**Addendum No. 2
January 20, 2023**

Project: Baltic High School Addition
Baltic, South Dakota
Arch Project No. 2957

Architect: Architecture Incorporated

3
5.40
DETAIL
SCALE: 1/2" = 1'-0"

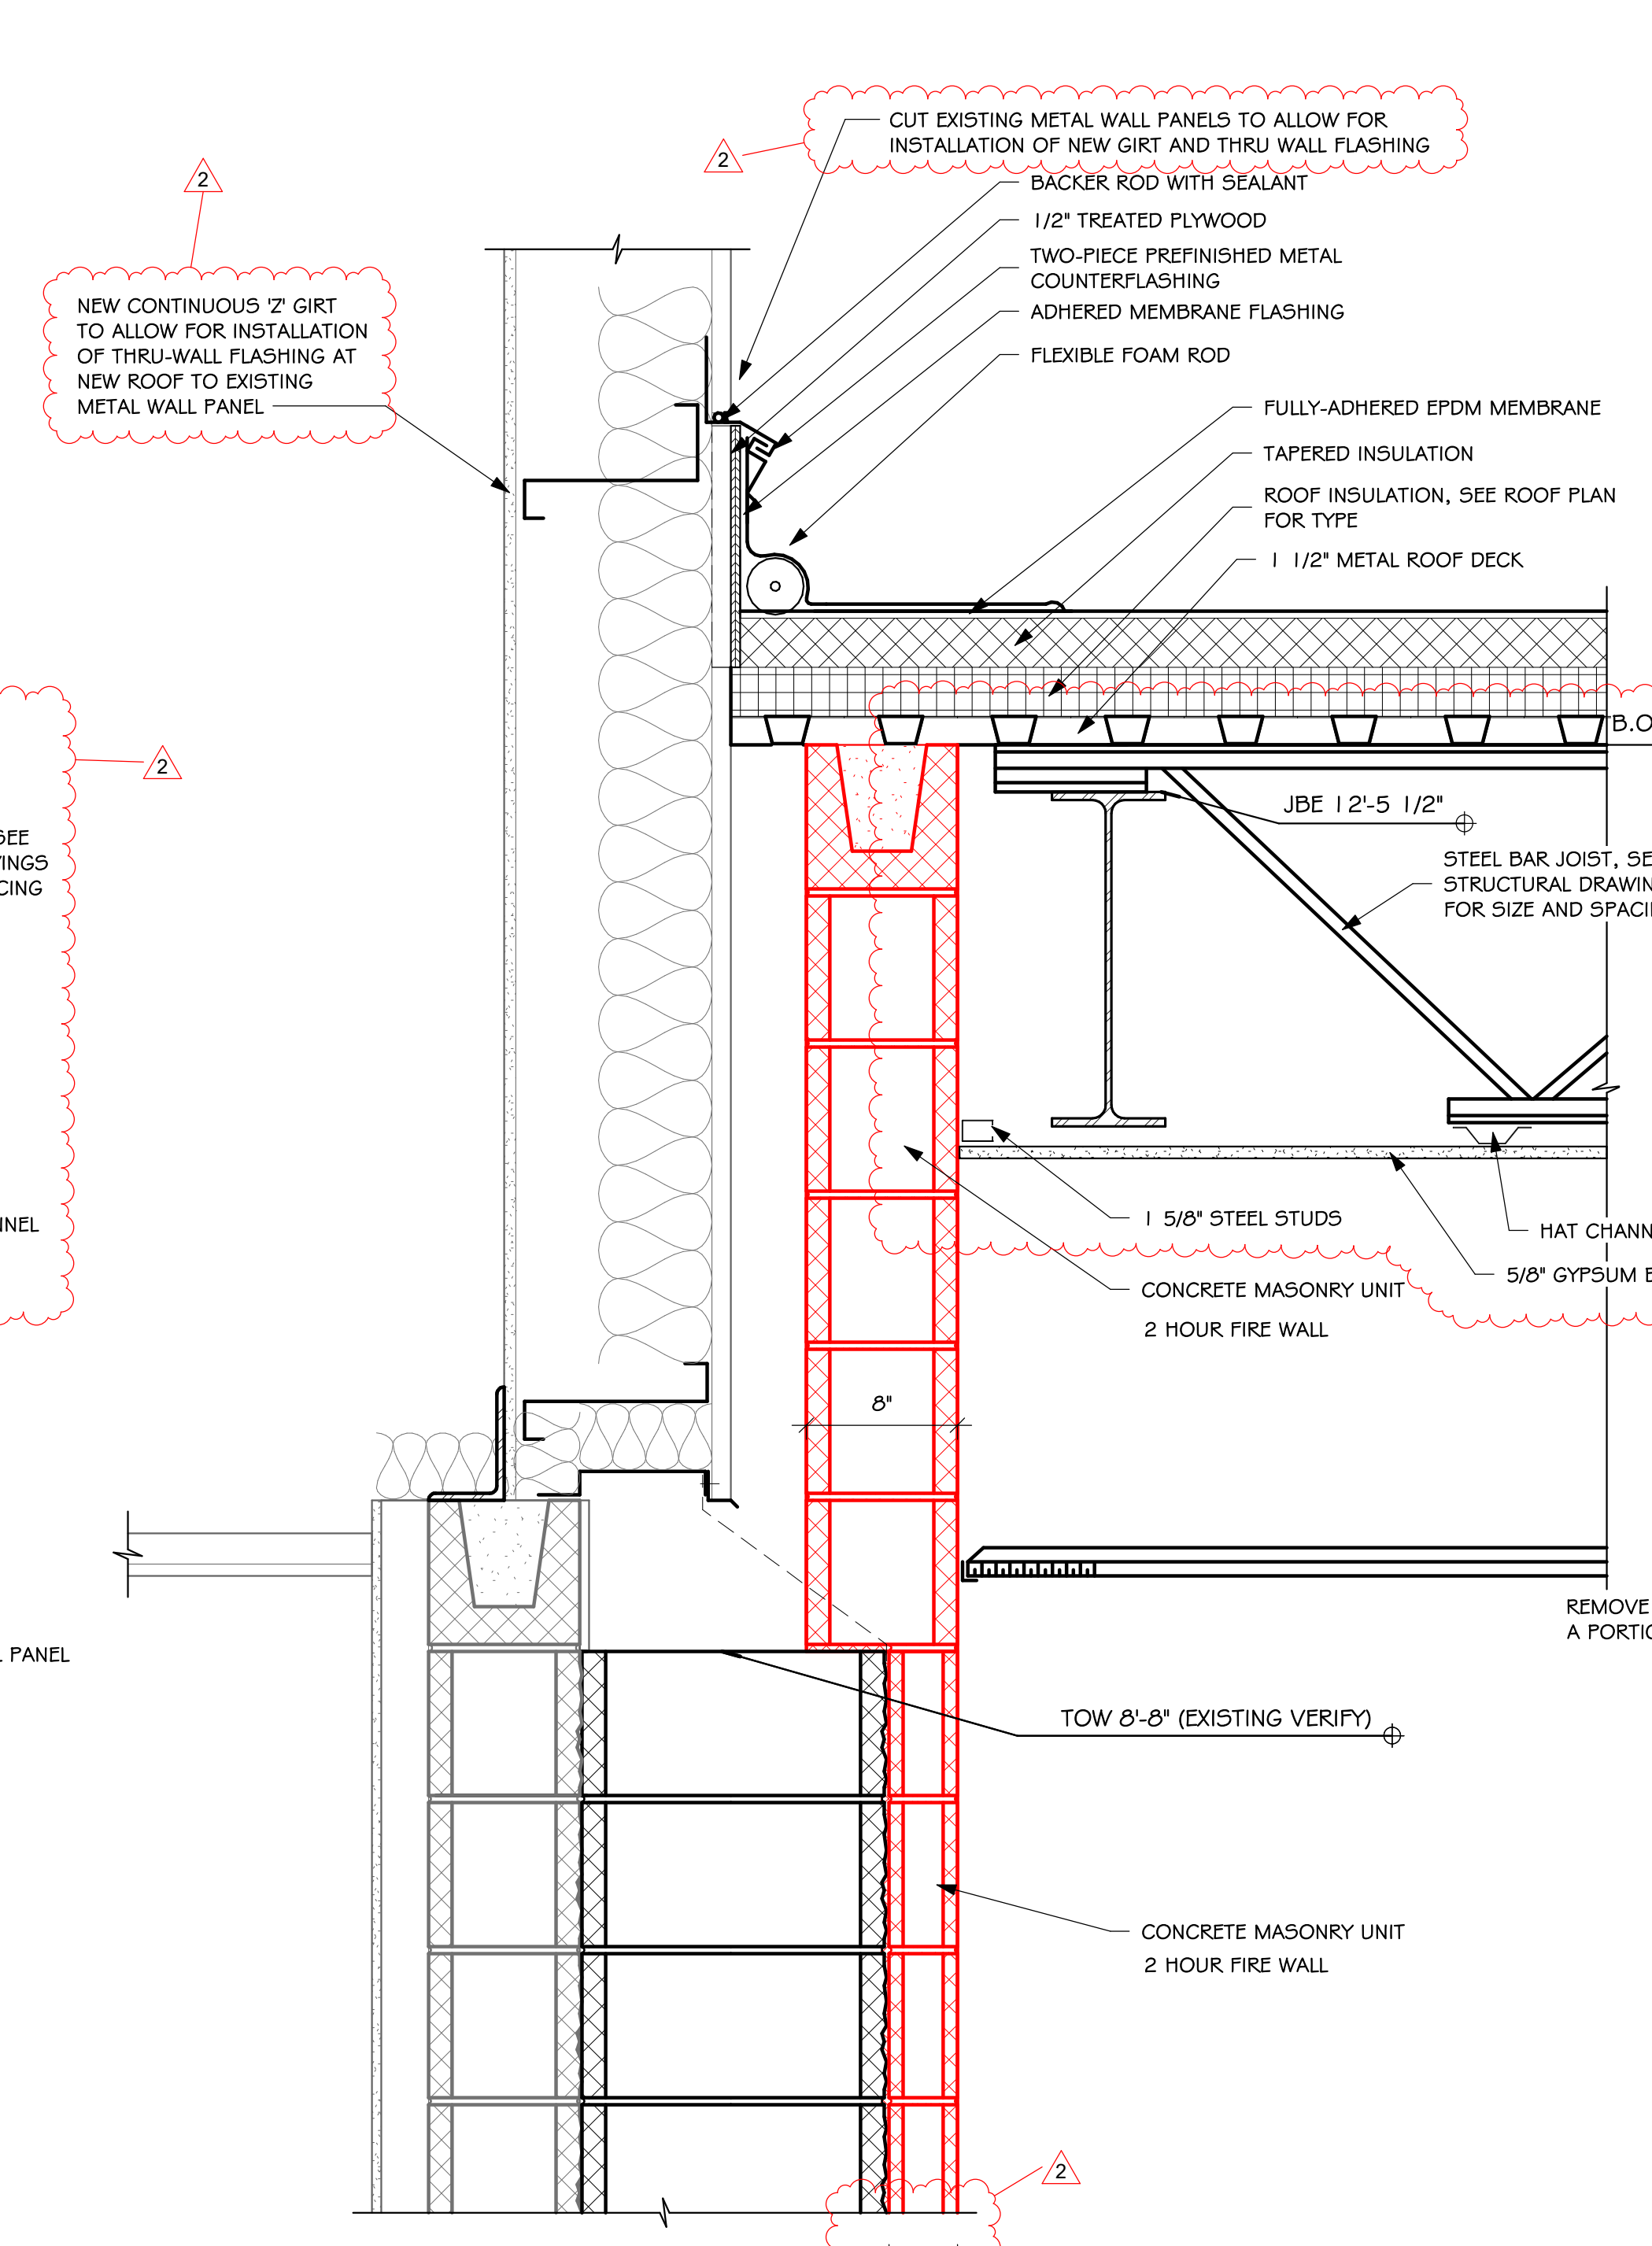
- a) Reference *revised* Sheet 5.40 (attached to the end of this addendum) for revised details 1, 2, 3 & 4/5.40.
 - i) Cut existing metal wall panels to allow for installation of thru-wall flashing and new ‘Z’ girt. ‘Z’ girt shall be installed continuous between existing metal building columns.
 - ii) Install 5/8” gypsum board on the underside of the steel bar joists & beams that occur from grid E1 to E7 and grids Ed and Ee.
 - (1) Along grid Ee, return gypsum board vertically to roof deck. Reference revised detail 3/5.42 on sheet 5.42 (attached).
 - (2) General: 5/8” gypsum board shall be required along the 2-hour fire wall between existing and new construction as indicated.

UNDERFLOOR PLAN - AREA G - PLUMBING

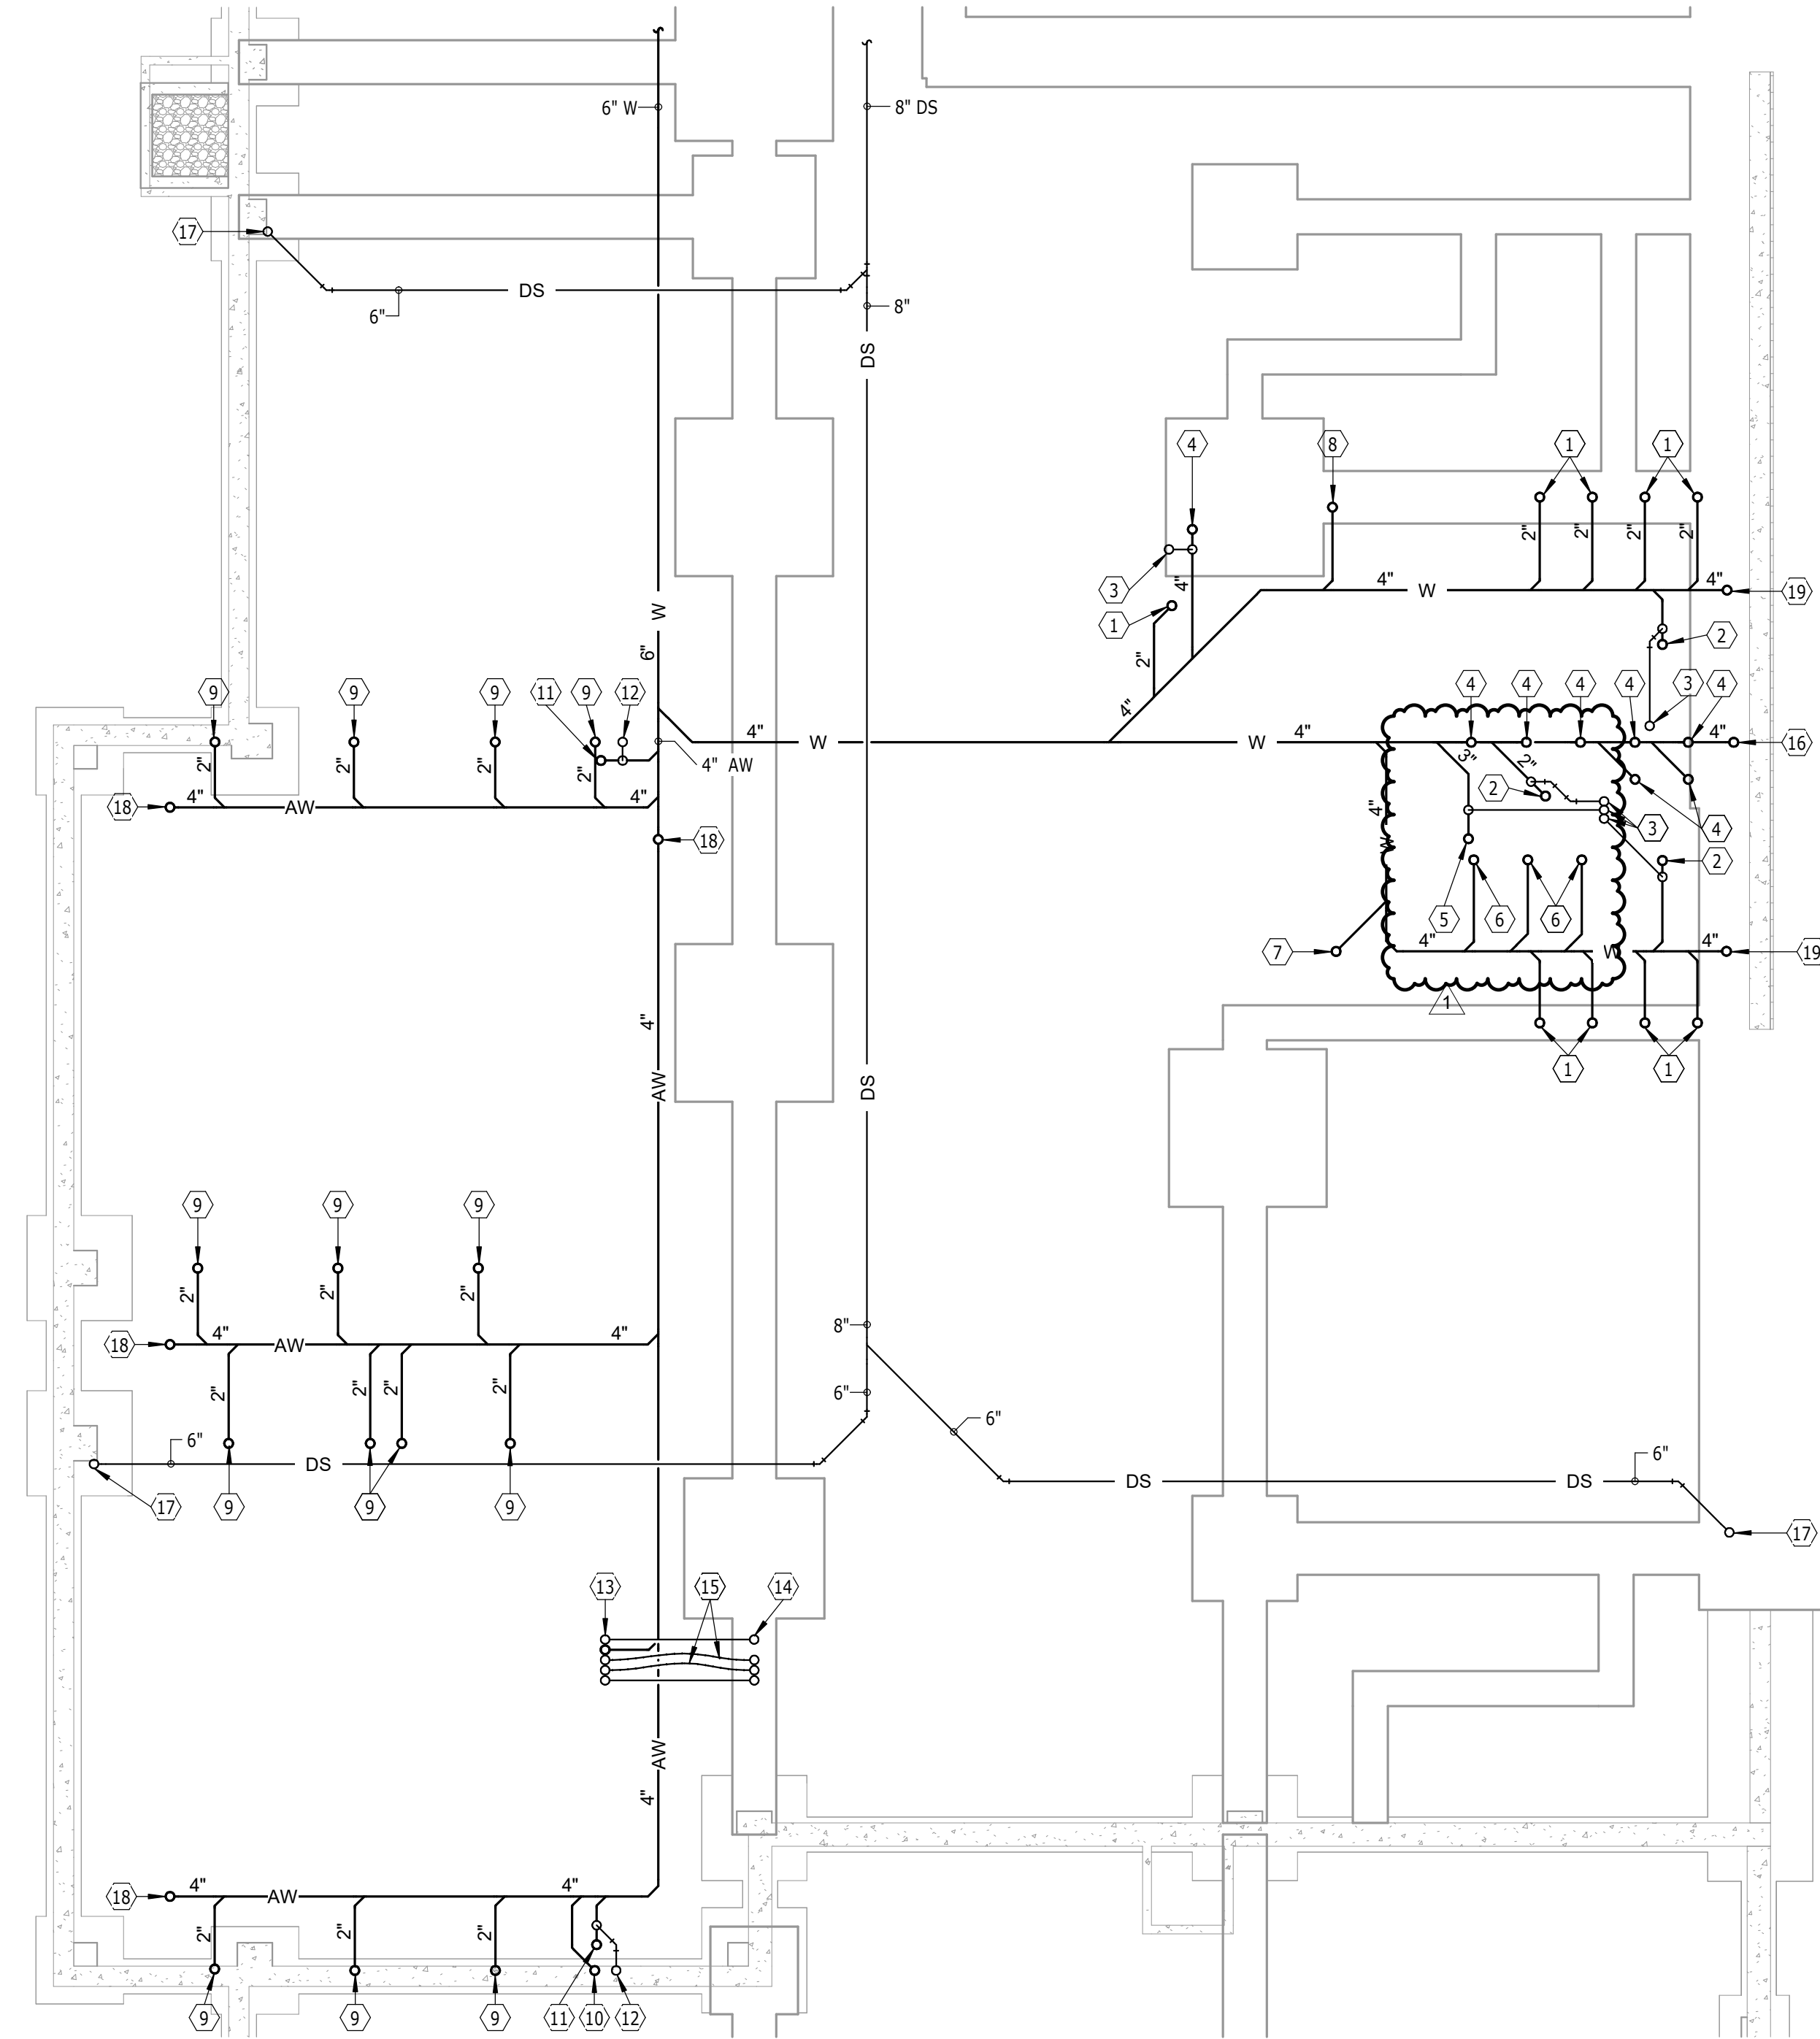
- i) See revised mechanical drawing Sheet 8.30 attached to the end of this addendum.
- 3) **SHEET 8.32 – UNDERFLOOR PLAN – AREA G – PLUMBING**
 - a) Modify mop sink location & associated piping as indicated per revised drawing Sheet 8.32, Addendum 2, dated 1/20/23.

8.36

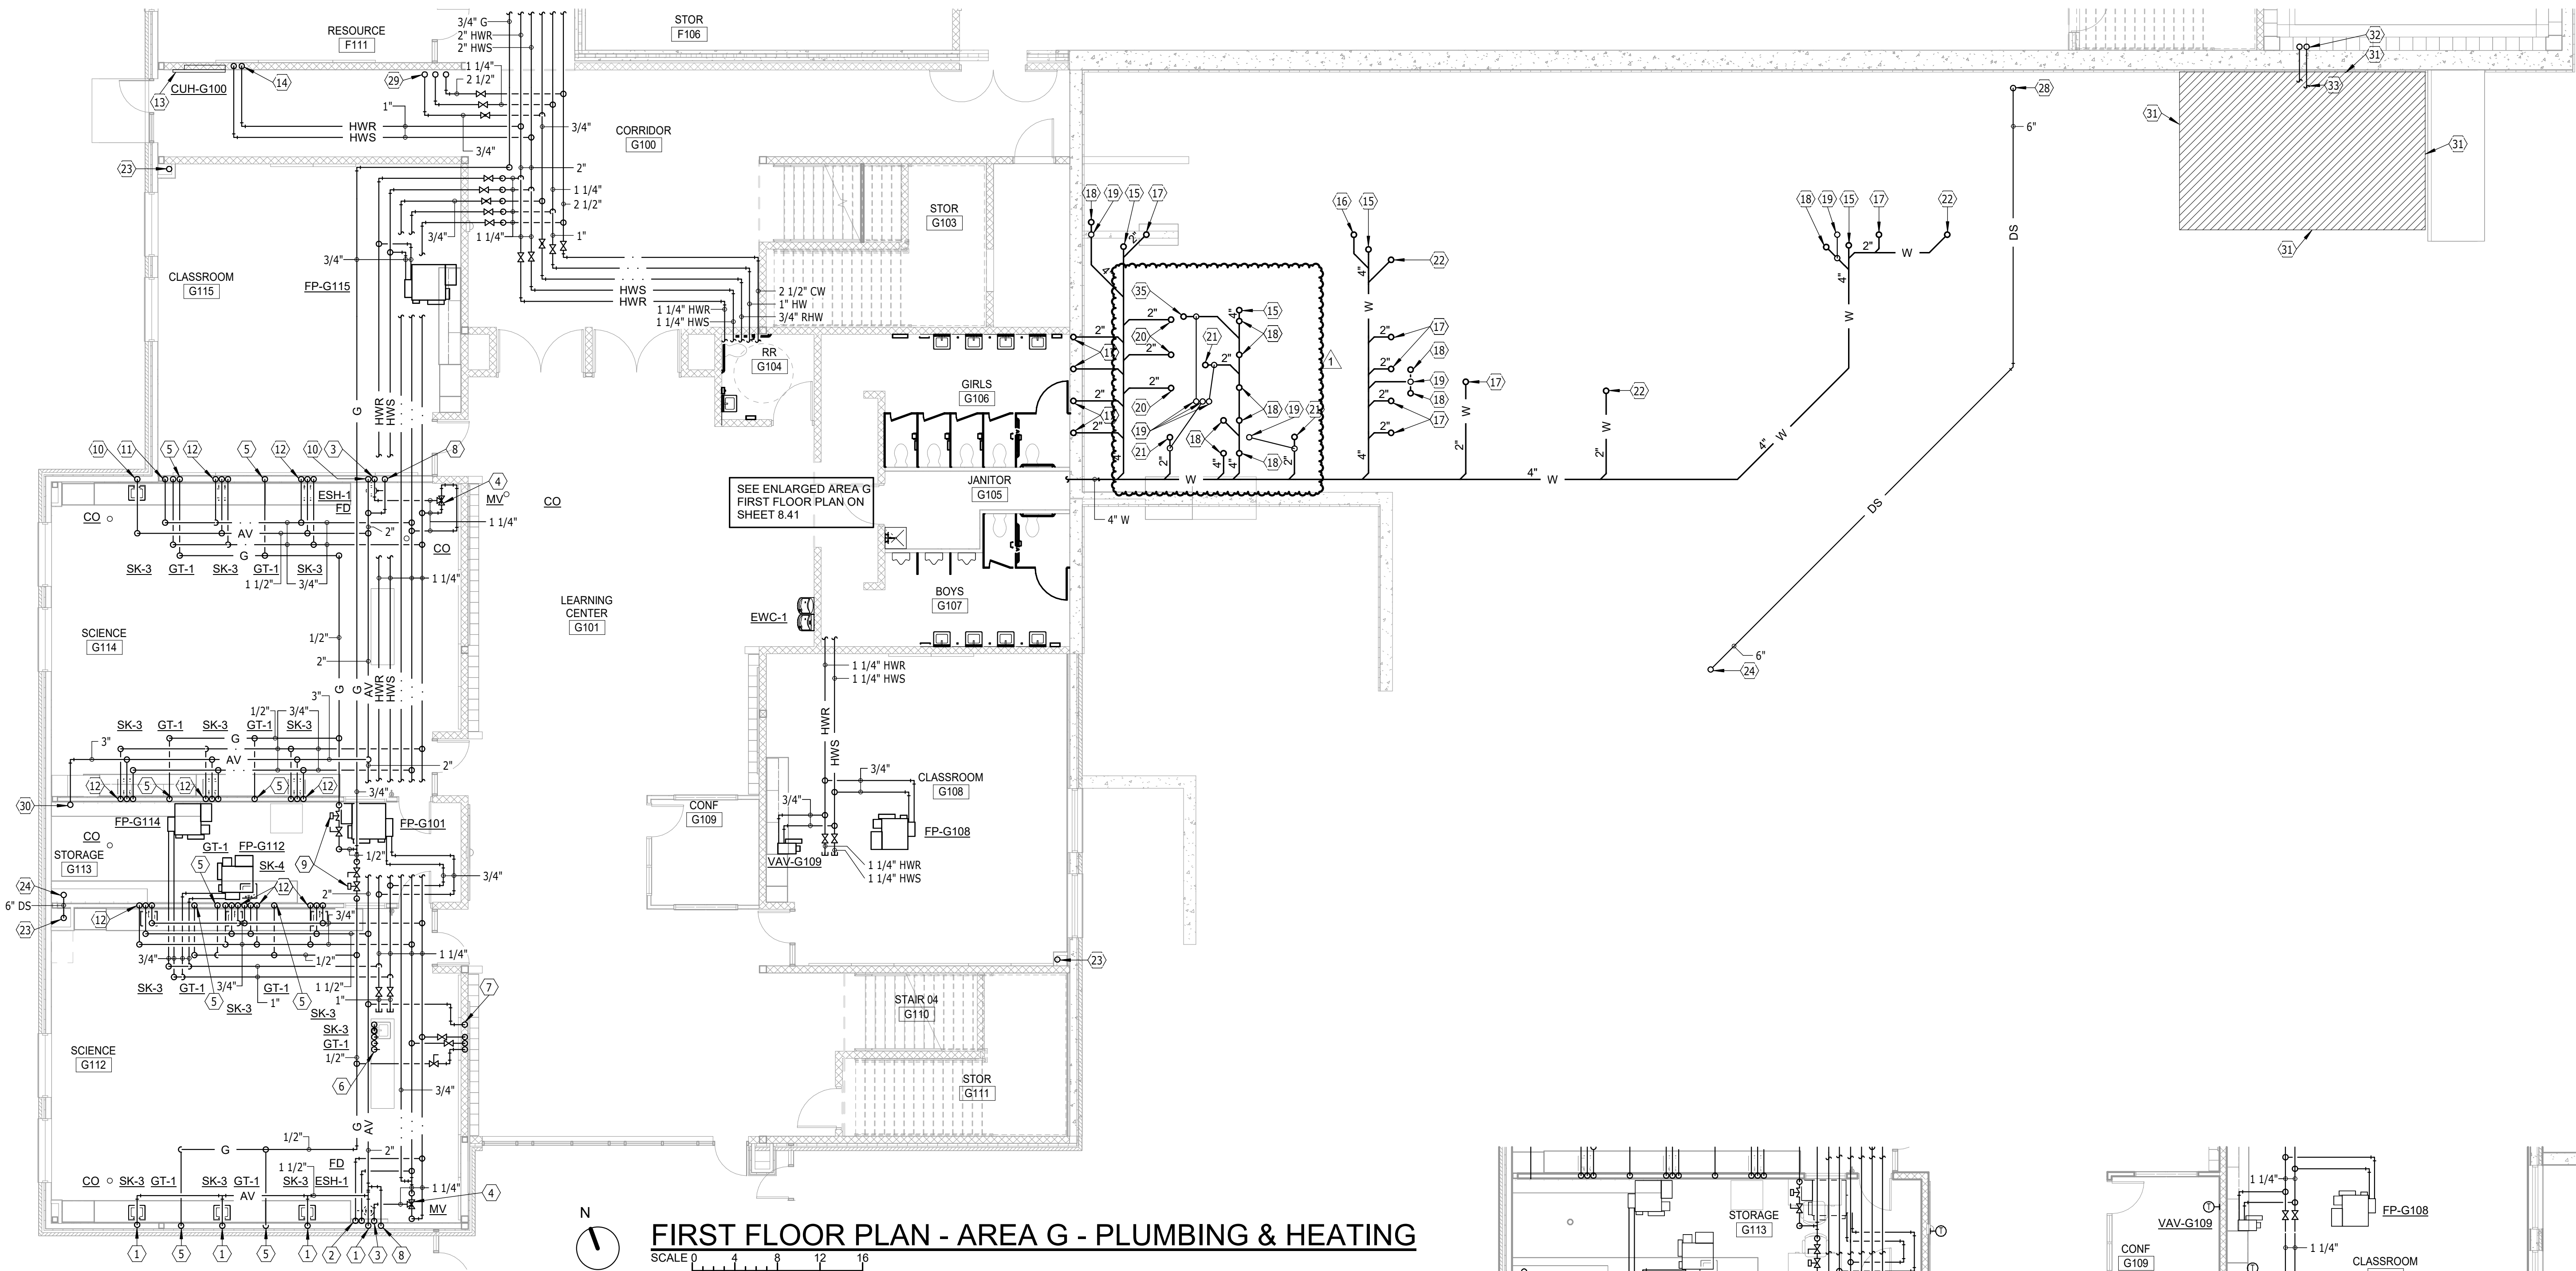
- a) BOYS LOCKER F128: Modify fire protection and water service piping as indicated per revised drawing Sheet 8.36, Addendum 2, dated 1/20/23.
 - i) See revised mechanical drawing Sheet 8.36 attached to the end of this addendum.
